DOCUMENT 00 90 00
ADDENDUM

ADDENDUM No.: 4

DATE: March 6, 2025

RE: WESTERN TECHNICAL COLLEGE
AUTOMOTIVE TECHNOLOGY CENTER ADDITION AND REMODEL
2721 LARSON ST.
LA CROSSE, WISCONSIN 54603
PROJECT NO. 24061

1 1ST FLOOR-LOW VOLTAGE - AREA A

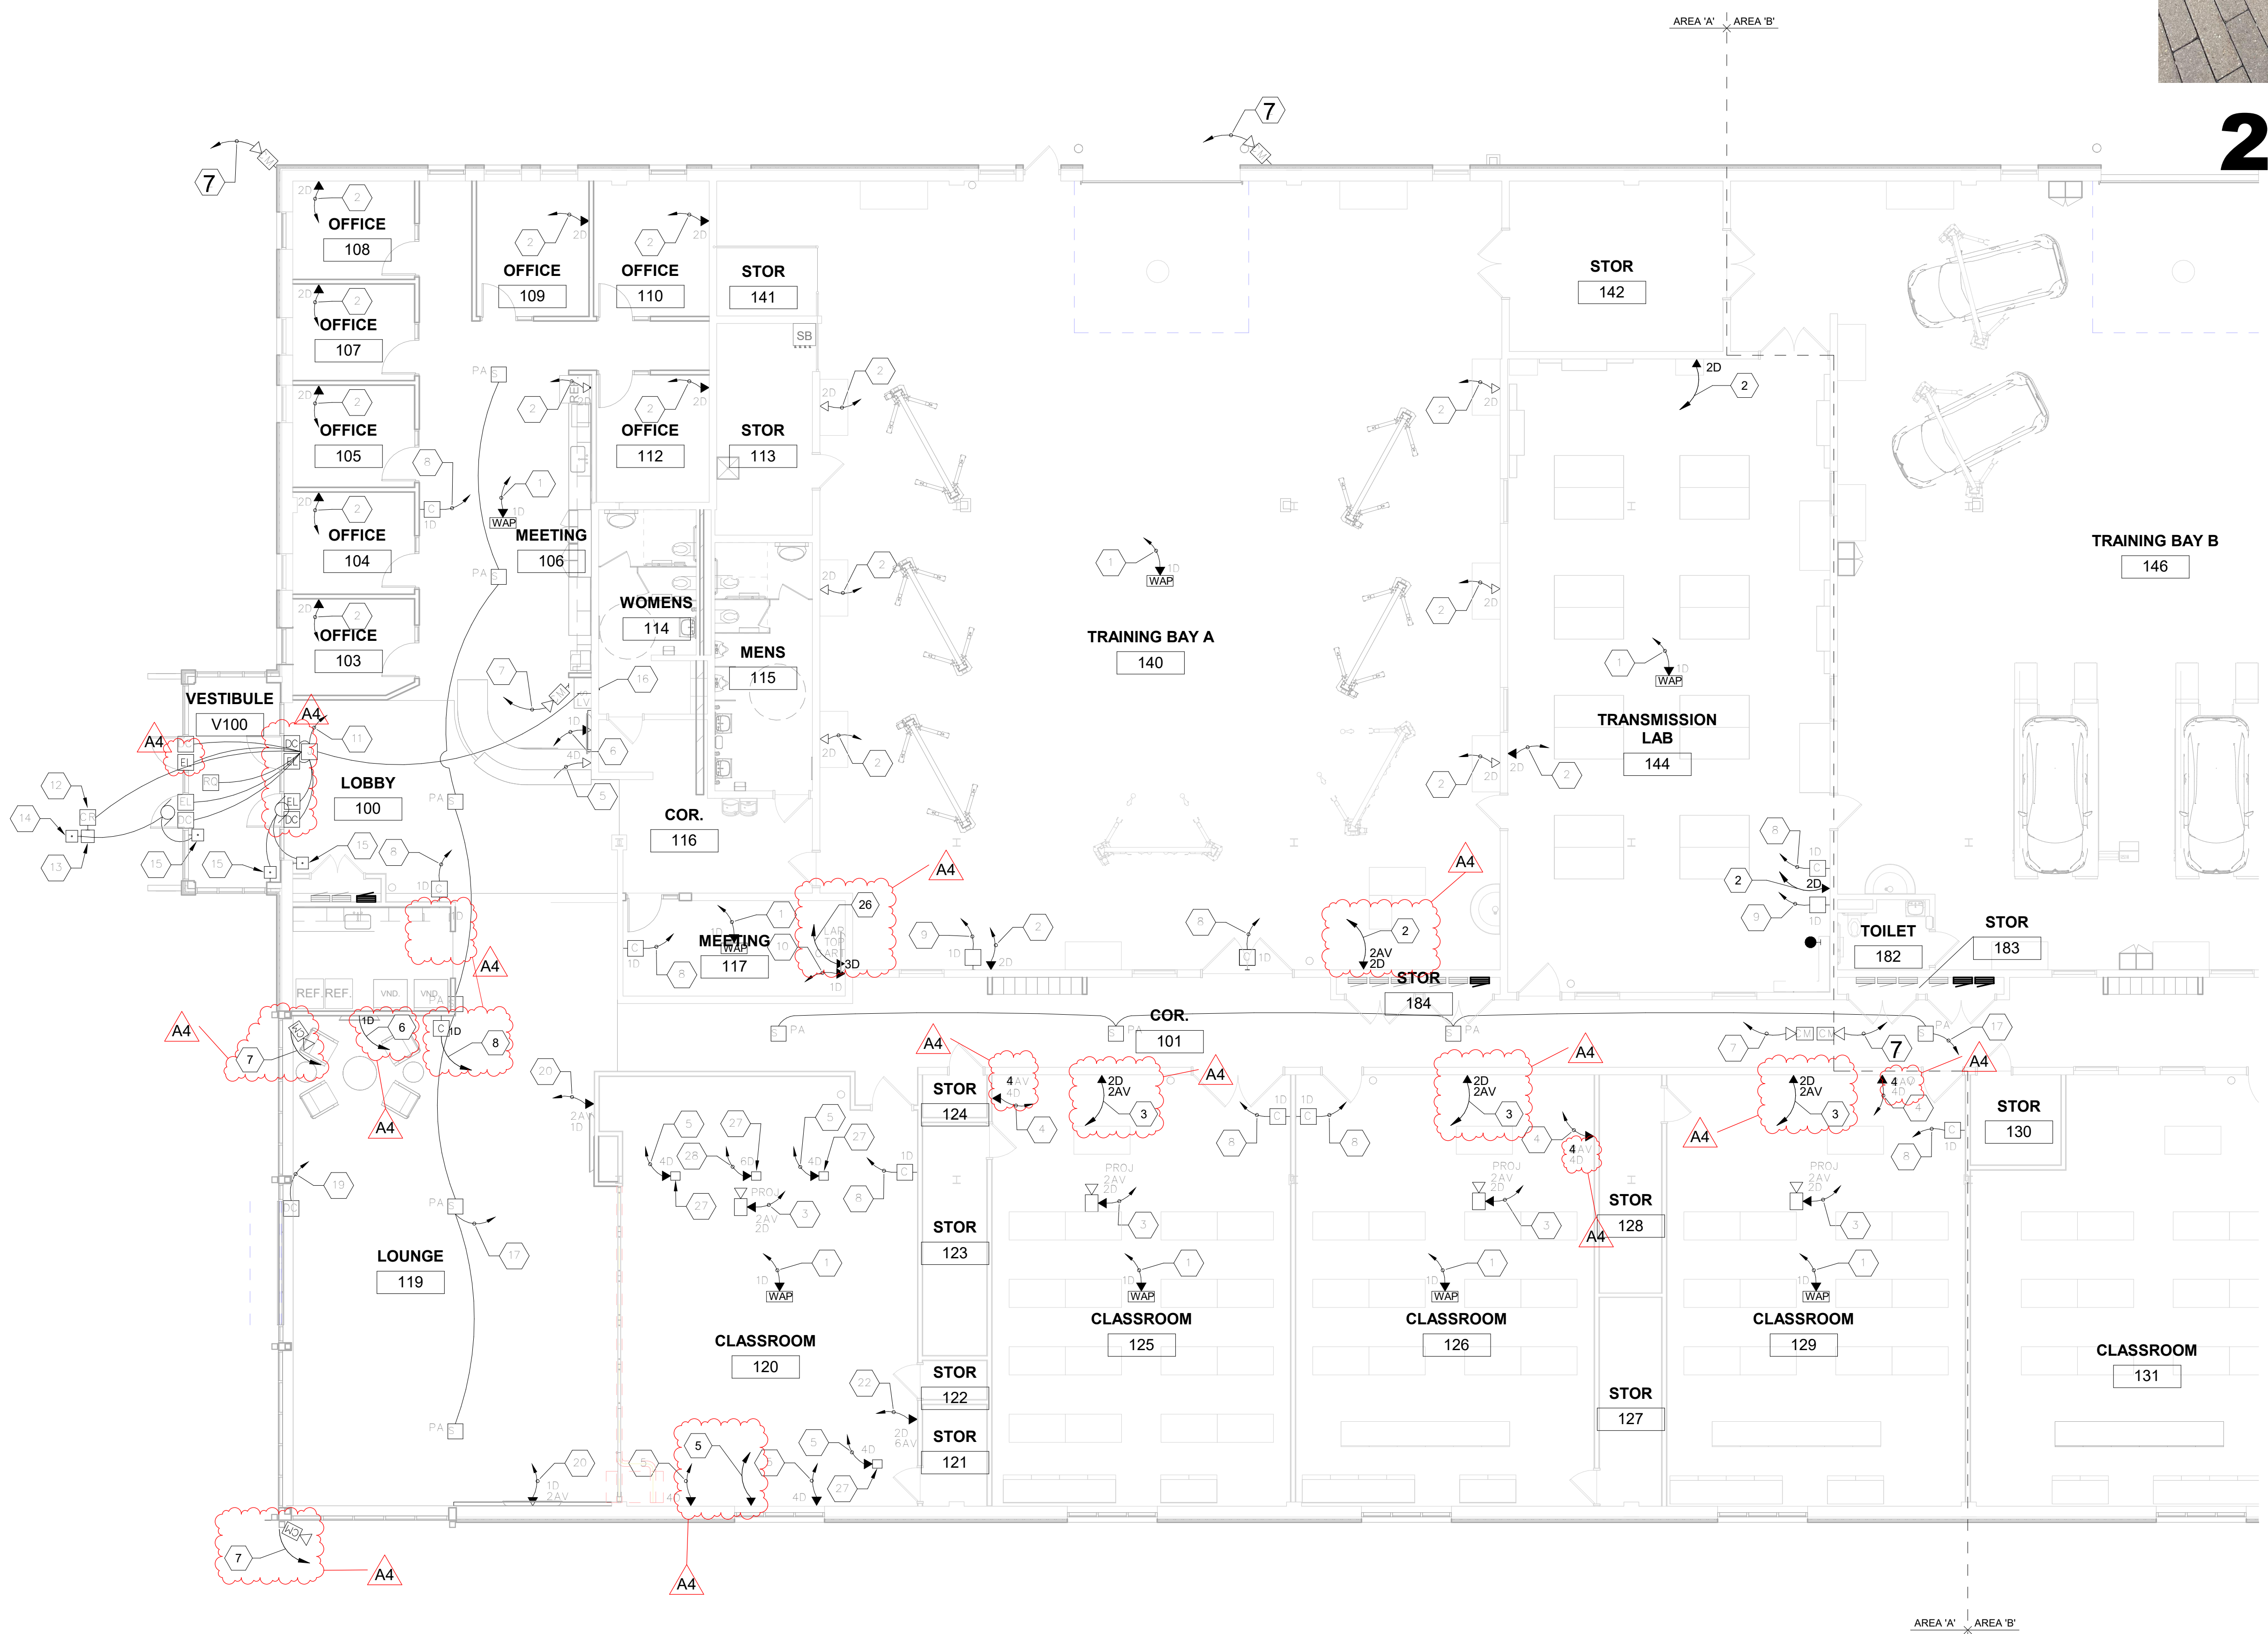
- a. See the revised sheet included in this addendum. Disregard the previous version.
 - b. Revised the entire sheet.
32. Sheet E301 1ST FL. ELECTRICAL LOW VOLTAGE PLAN – AREA A 30"x42"

- a. See the revised sheet included in this addendum. Disregard the previous version.
 - b. Added data drops and modified number of ports in data drops.

- c. Relocated data drop for clock.
33. Sheet E302 1ST FL. ELECTRICAL LOW VOLTAGE PLAN – AREA B 30"x42"
 - a. See the revised sheet included in this addendum. Disregard the previous version.

1 1ST FLOOR-LOW VOLTAGE - AREA B
1/8" = 1'-0"

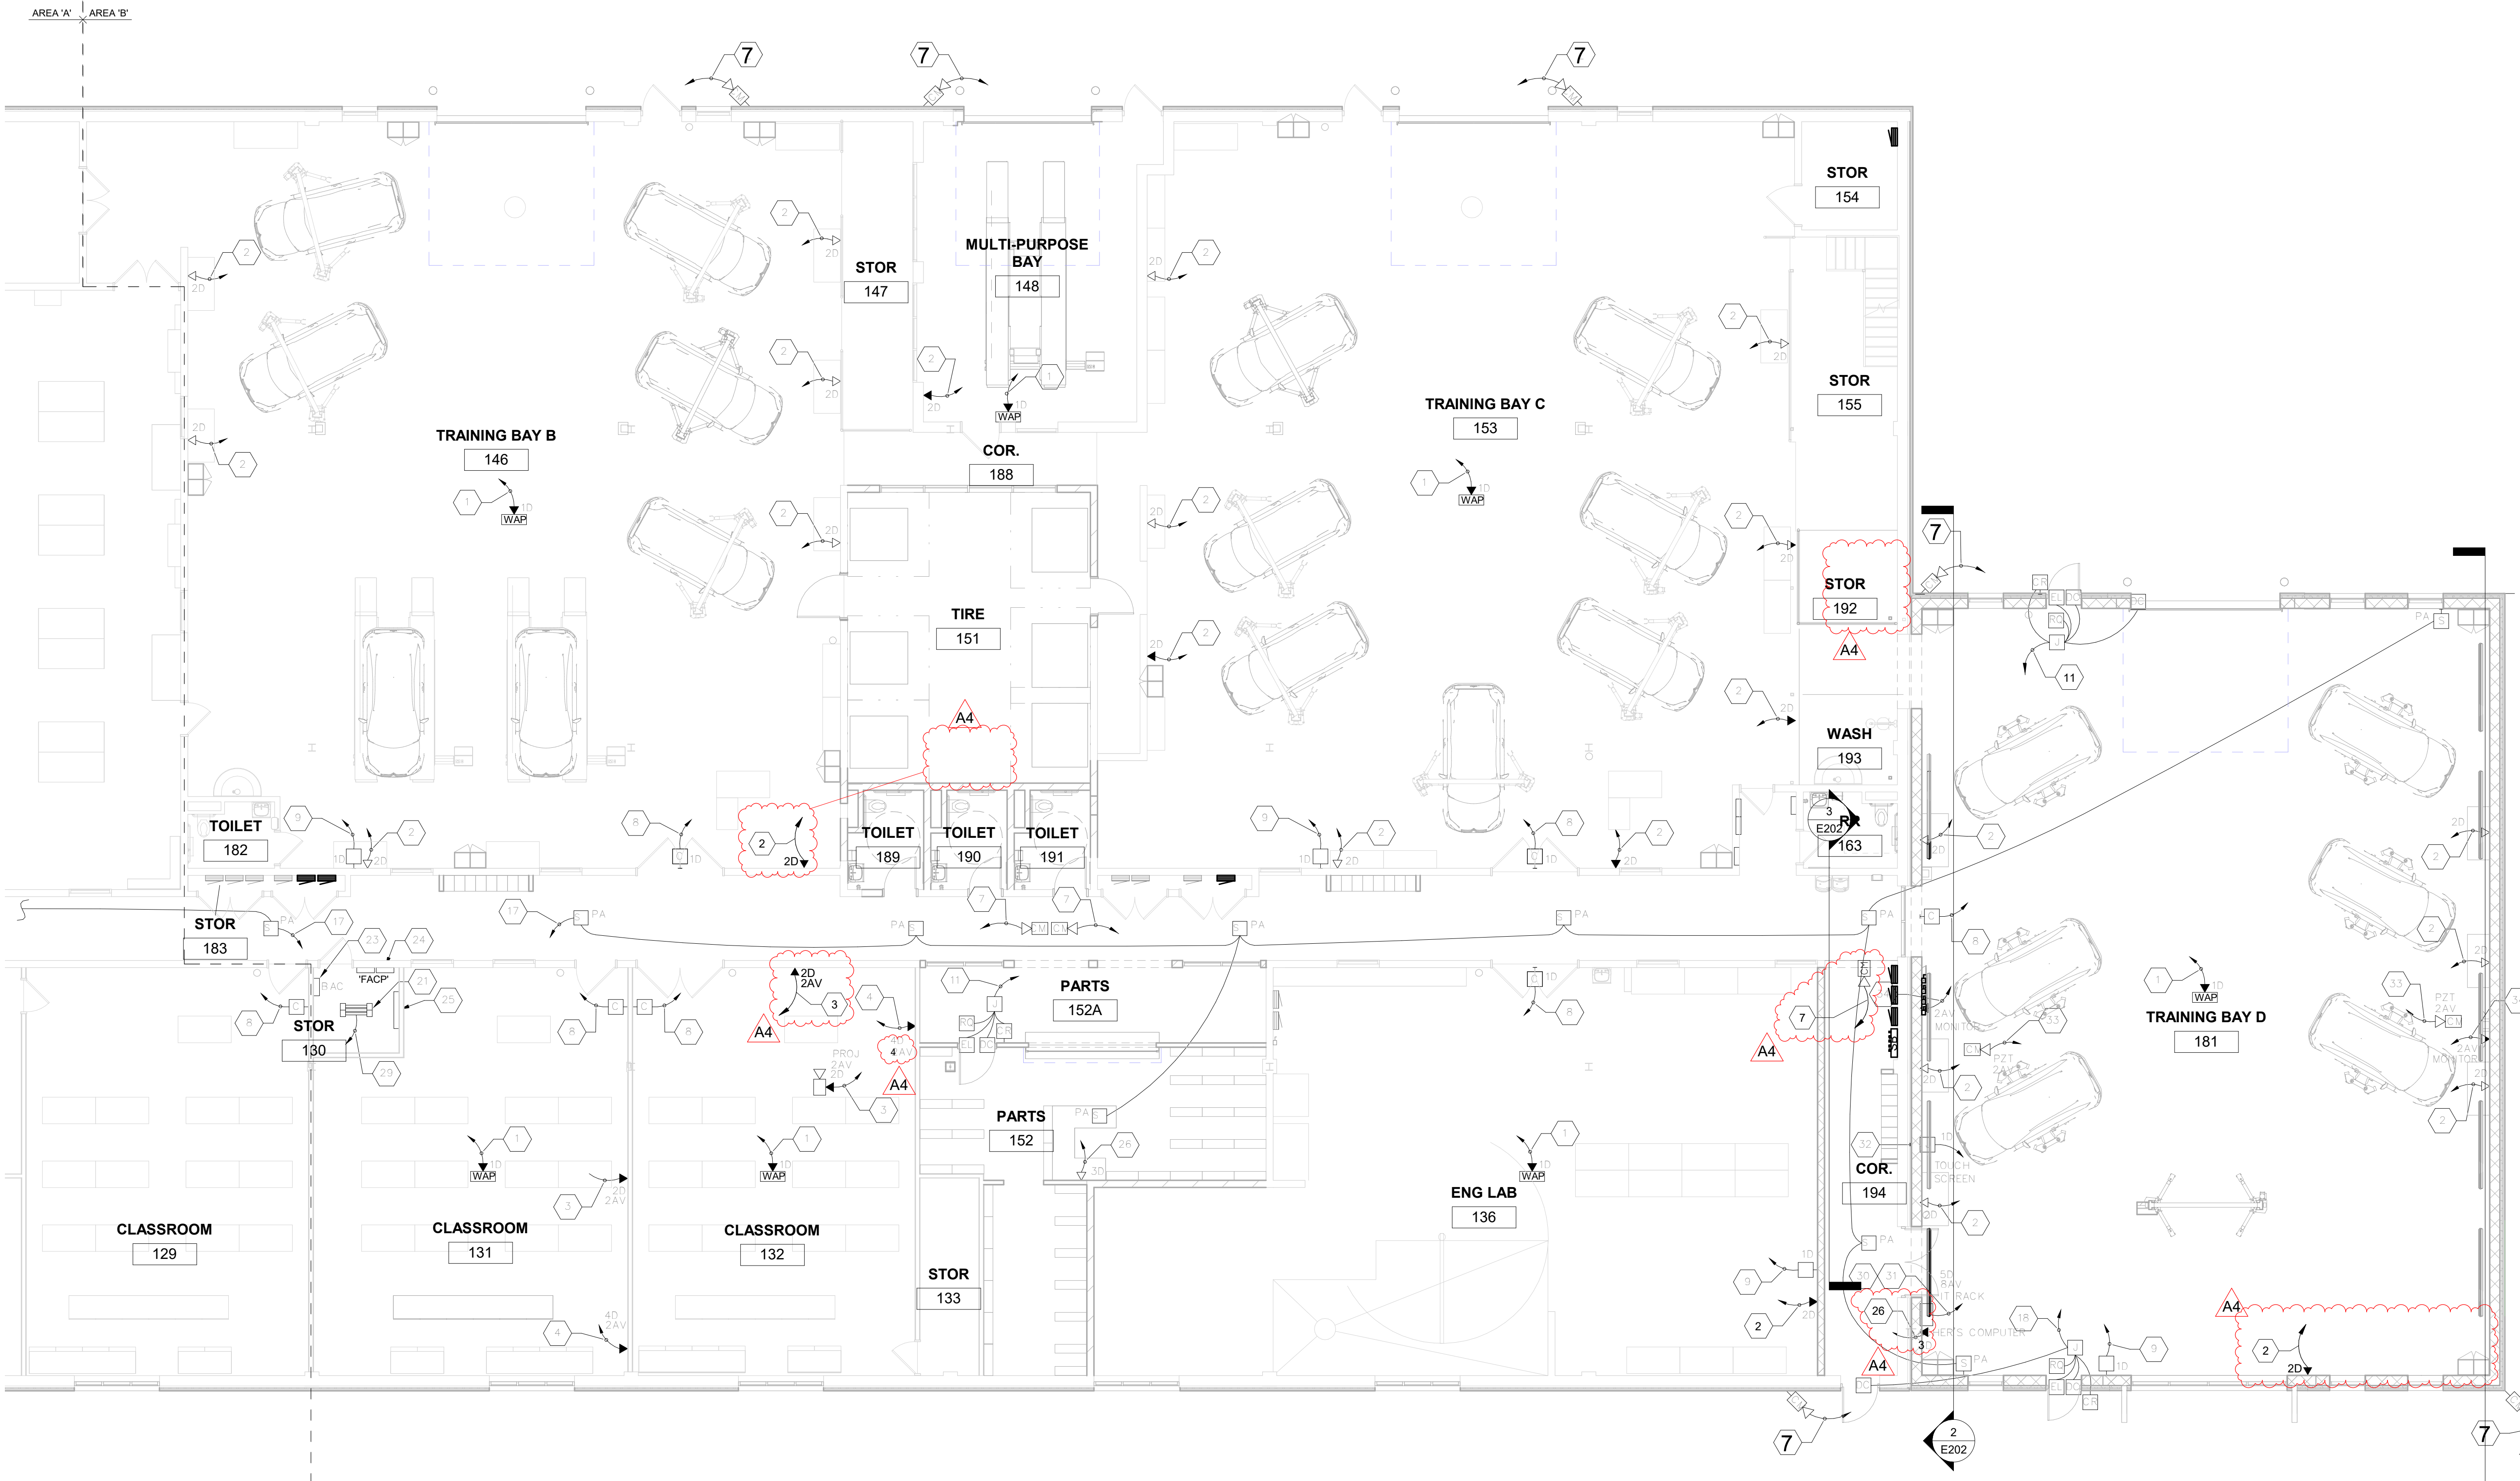
- b. Added data drops and modified number of ports in data drops.
 - c. Added section view callouts.
34. Sheet E500 ELECTRICAL PANELS SCHEDULES 30"x42"
 - a. See the revised sheet included in this addendum. Disregard the previous version.
